Senior Administrative Officer,
Planning Department,
South Dublin County Council,
County Hall,
Town Centre,
Tallaght,
Dublin 24

Our Ref: 21047

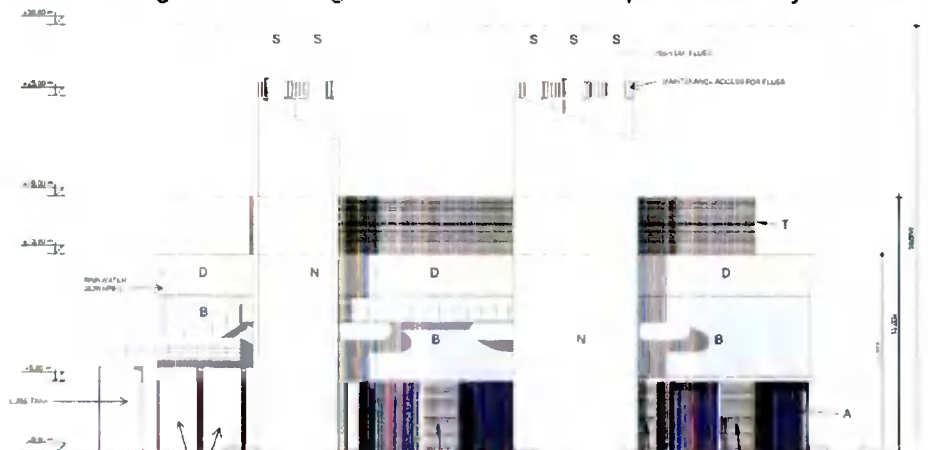
We note the clarifications sought by the Planning Authority in relation to what was referred to as the Permanent power plant under the originally submitted application, and is now referred to as the Multi-Fuel Generation Plant under this AI response. Its redesign required it to be remodelled from a noise and air quality perspective. Their original height of 25m, due to their repositioning were resulting in them negatively impacting the cooling capabilities of the chillers on the roof of the data centers that would require more energy to cool the facility, which is a key component of the workings of a data centre.
